Addendum No. 3

Date:	April 8, 2013
To:	Contractors
From:	Matthias Mueller – Program Director
Reference:	Bachelor Enlisted Quarters Facility Utah National Guard – Camp Williams, Utah DFCM Project No. 10281480
Subject:	**Addendum No. 3**

ADDENDUM THREE

BACHELORS ENLISTED QUARTERS FACILITY

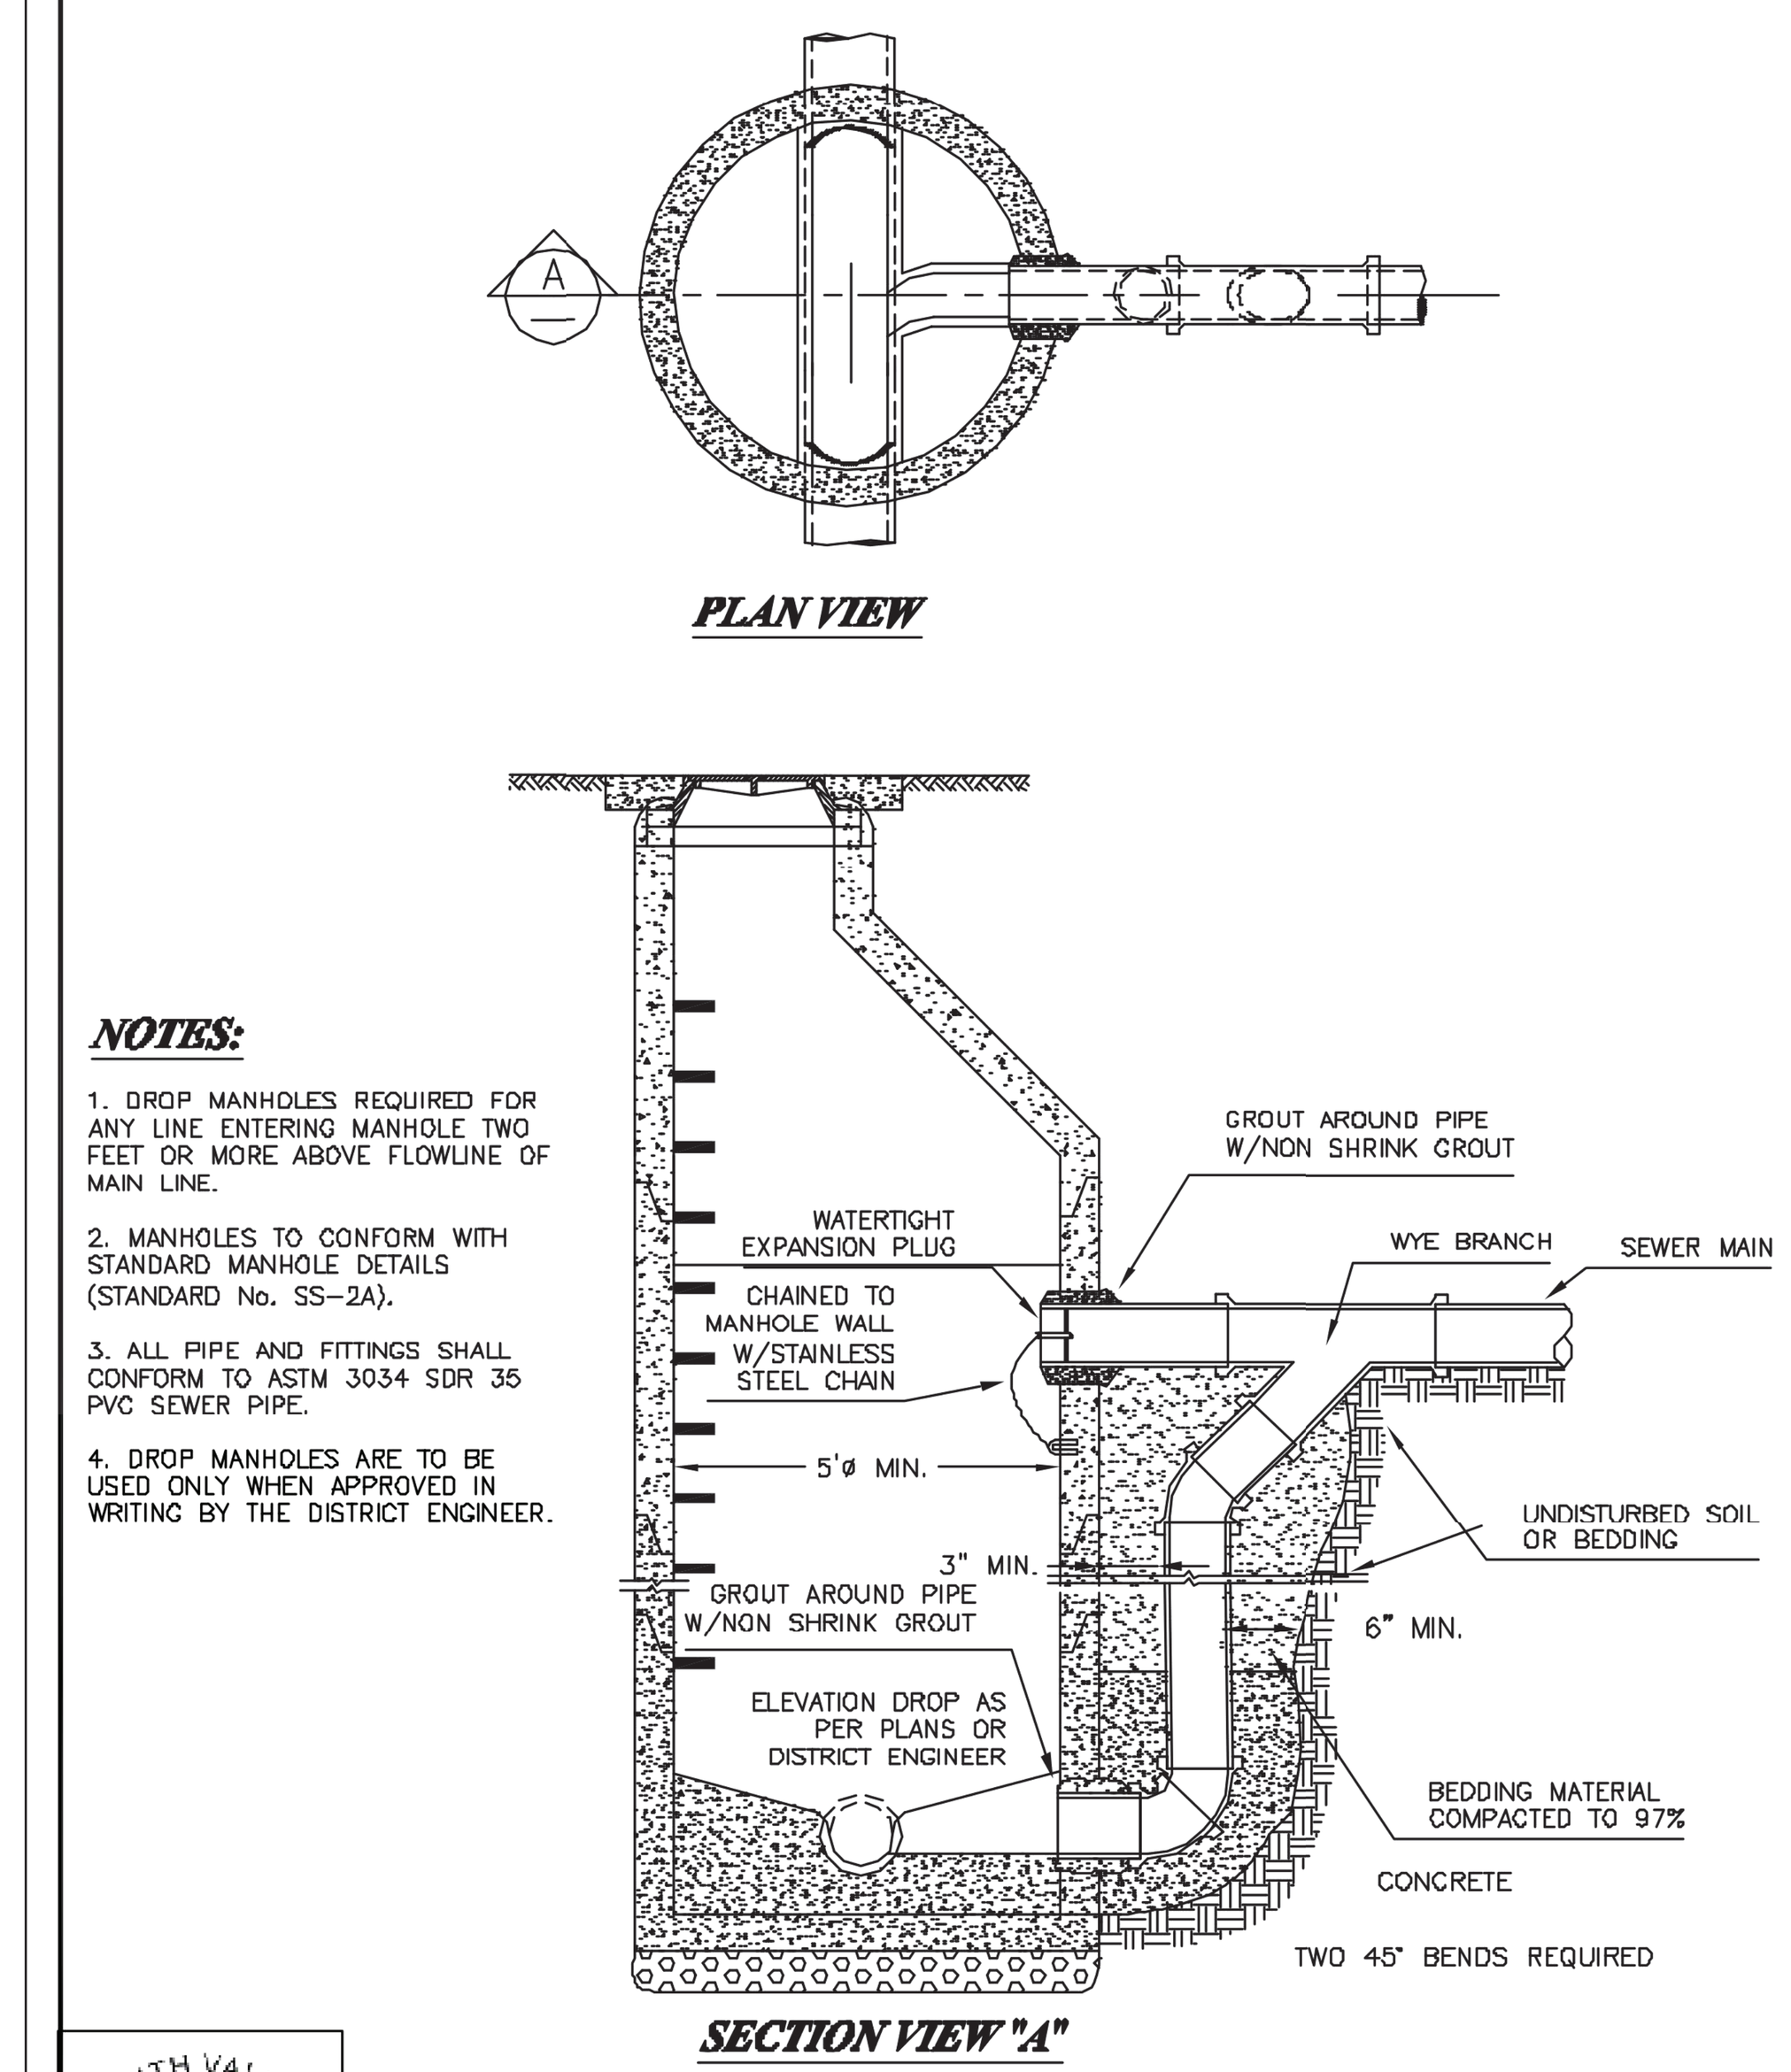
3.C04 Replace sheet C501 with enclosed revised sheet C501. The following are the updates made:

- Added a new drop manhole detail.

C1 PRECAST CONCRETE REVEALS AND JOINTS
6" = 1'-0"

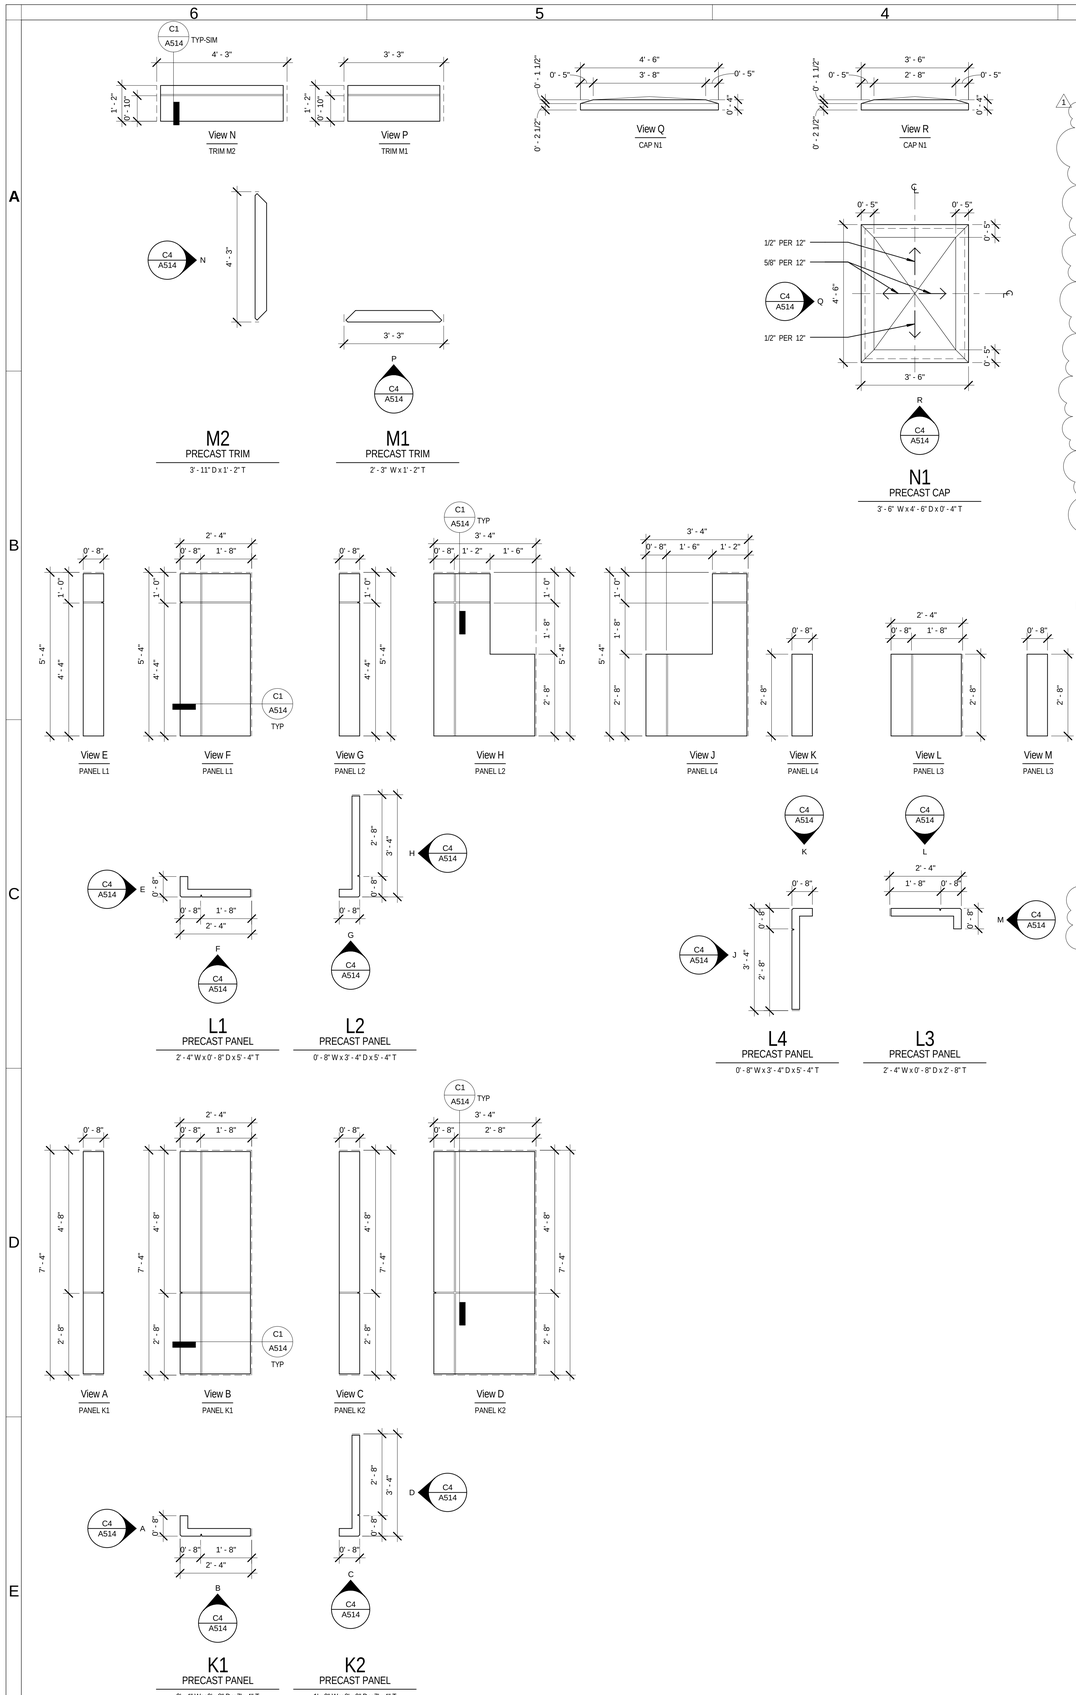
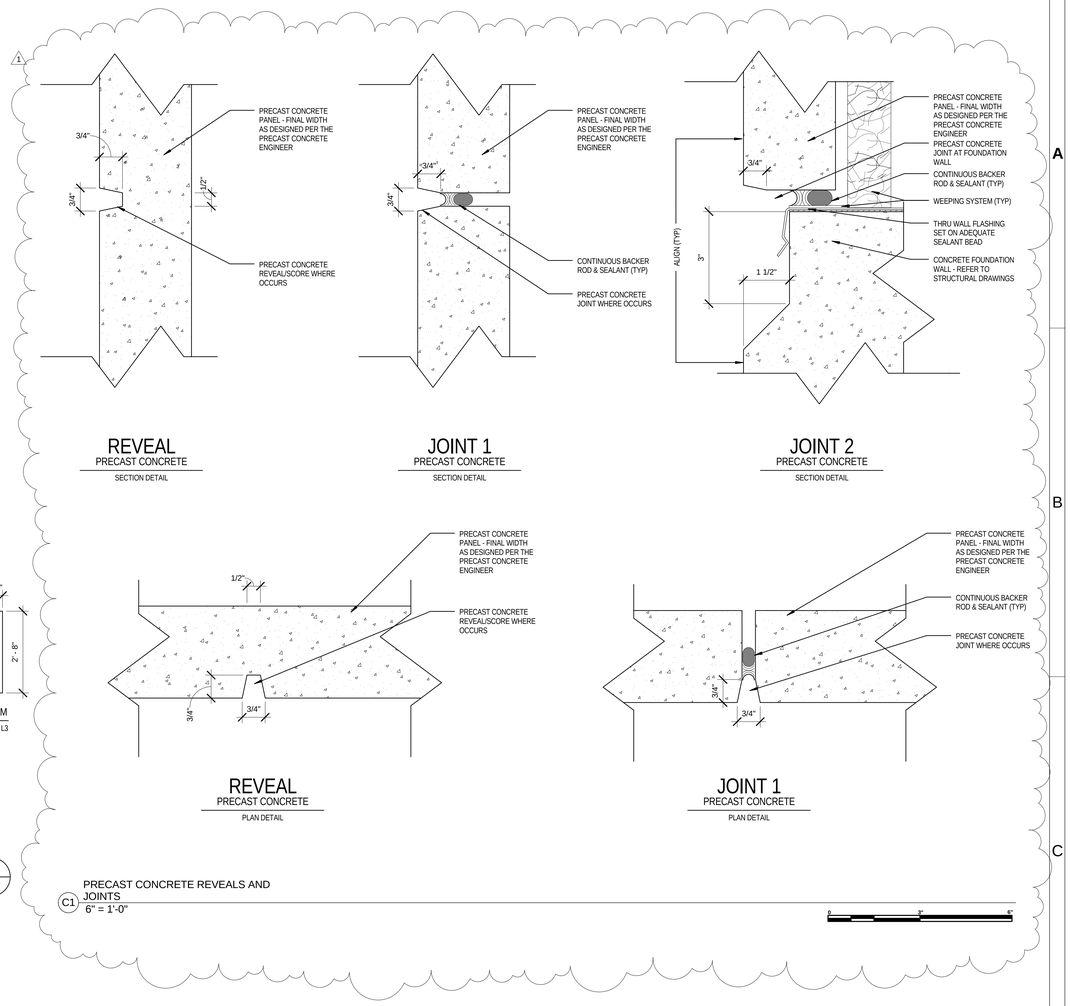
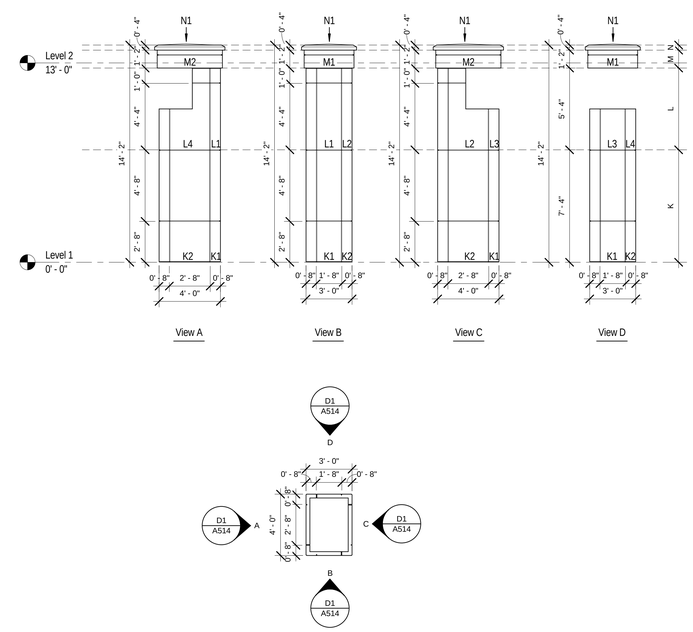
3.QA11 Request clarification of an item or treatment called out in the architectural drawing for the UNG Bachelors Enlisted Quarters. Detail C1/ A514 calls for "Exterior Weather Sealant" please let us know what is wanted.

3.A01 Replace sheet A514 with enclosed updated A514. The following are the updates made:

Response: Remove the exterior weather sealant from the precast concrete details.

1 FIRST LEVEL OVERALL PLUMBING PLAN
SCALE: 1/16" = 1'-0"

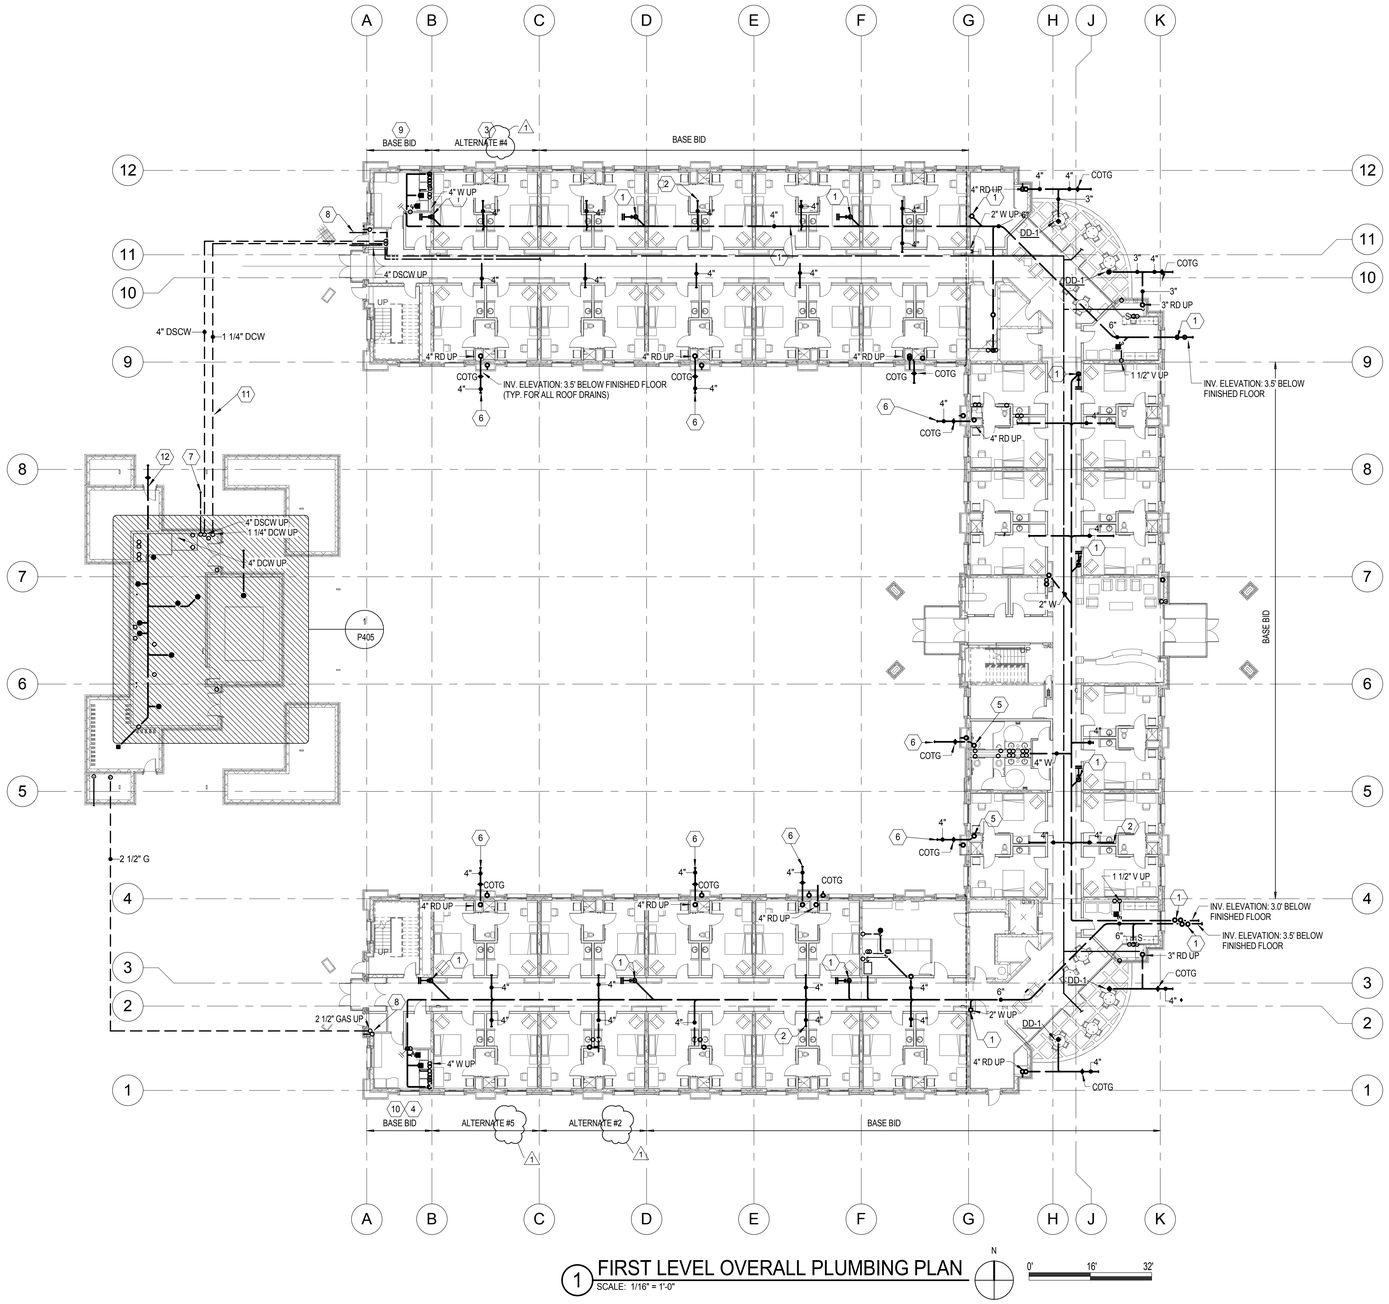
3.M01 On Sheet P101A add the following keyed note near the "Base Bid" indicator between gridlines 'A' and 'B' on the south wing: IF ALTERNATE #2 IS NOT INCLUDED IN THE PROJECT, ALL CONSTRUCTION WITHIN GRIDS 1 TO 4 AND A TO C IS TO MOVE SUCH THAT GRID C IS ALIGNED WITH GRID D. COORDINATE WITH ARCHITECTURAL PLANS.

3.M02 On sheet P101A add the following keyed note near the "Base Bid" indicator between gridlines 'A' and 'B' on the south wing: IF ALTERNATE #5 IS NOT INCLUDED IN THE PROJECT, ALL CONSTRUCTION WITHIN GRIDS 1 TO 4 AND A TO C IS TO MOVE SUCH THAT GRID C IS ALIGNED WITH GRID D. COORDINATE WITH ARCHITECTURAL PLANS.

E6 SITE ELECTRICAL PLAN
SCALE: 1" = 30'-0"

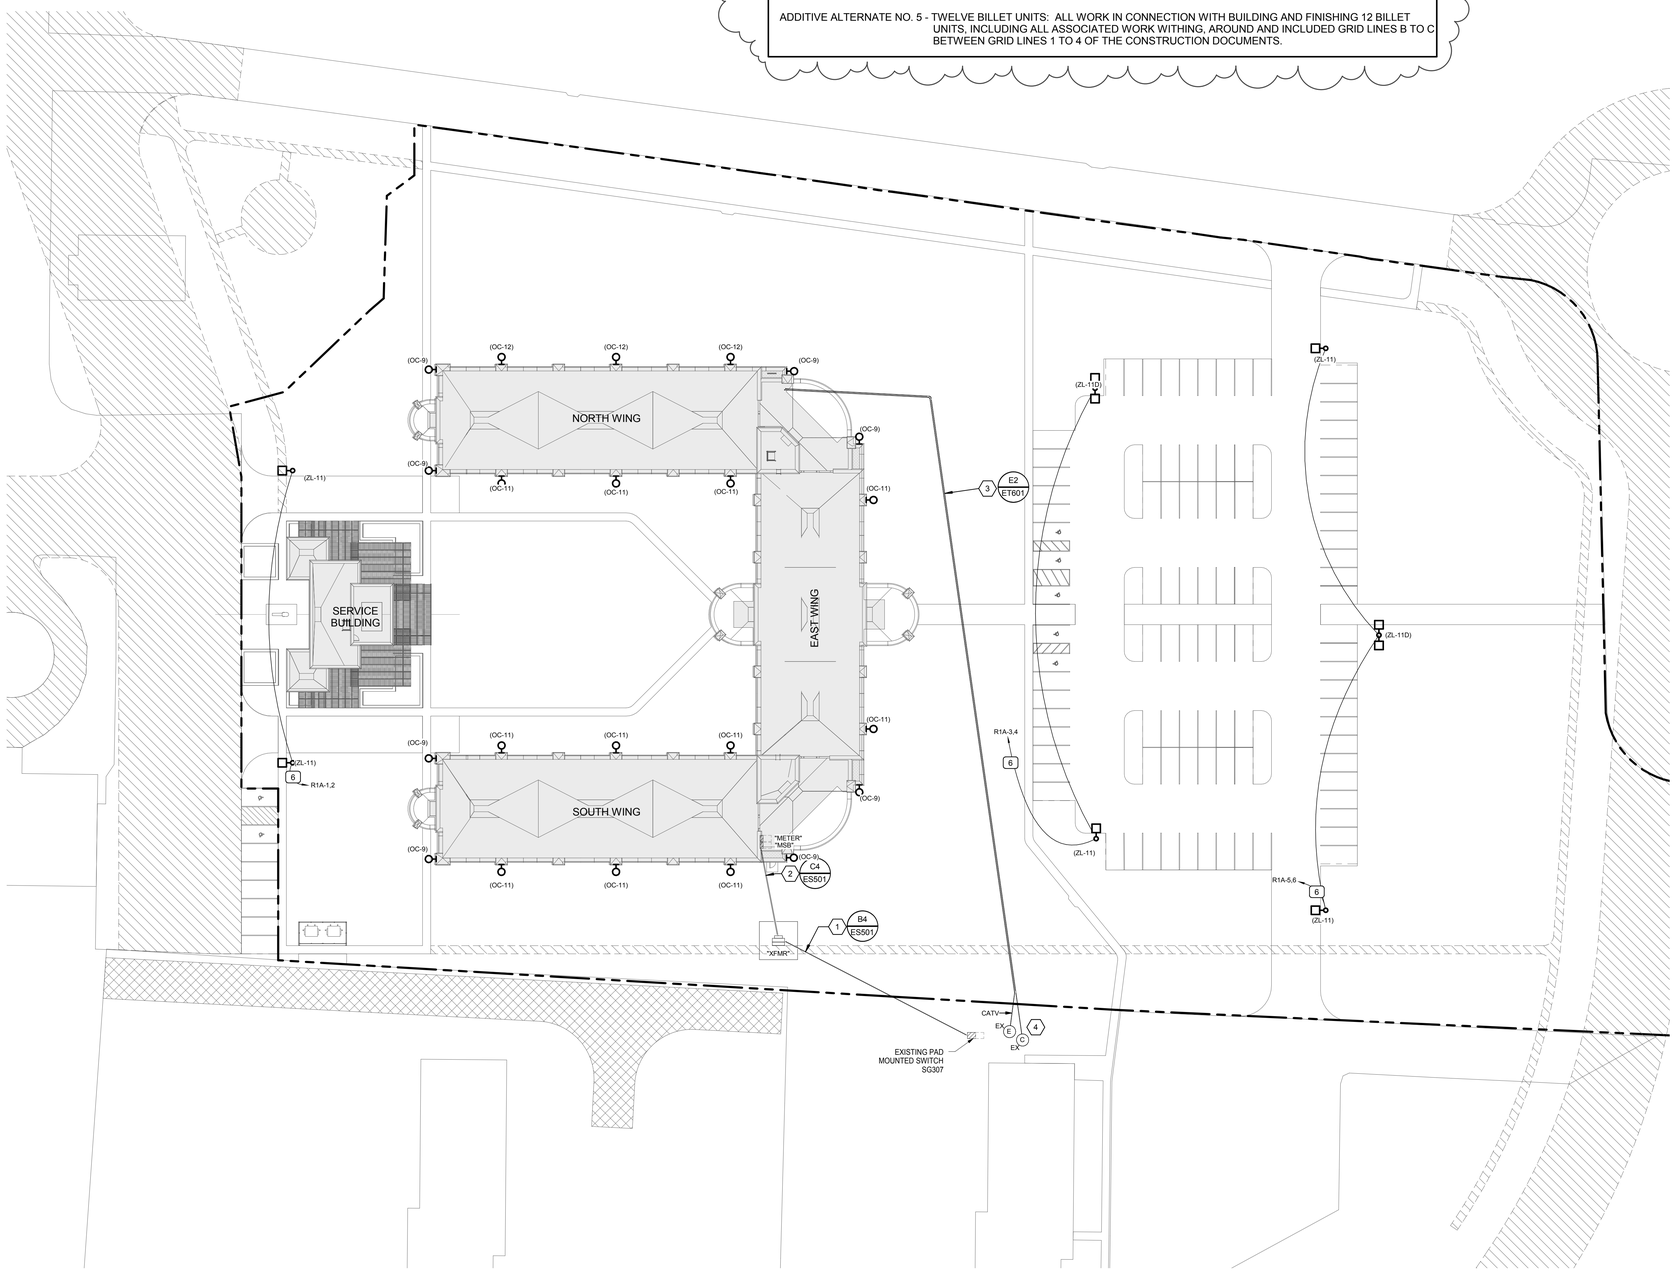
3.E01 Sheet ES101 – Added description for the bid alternates. Bid alternates shall apply to all electrical sheets. See the attached sheet ES101.
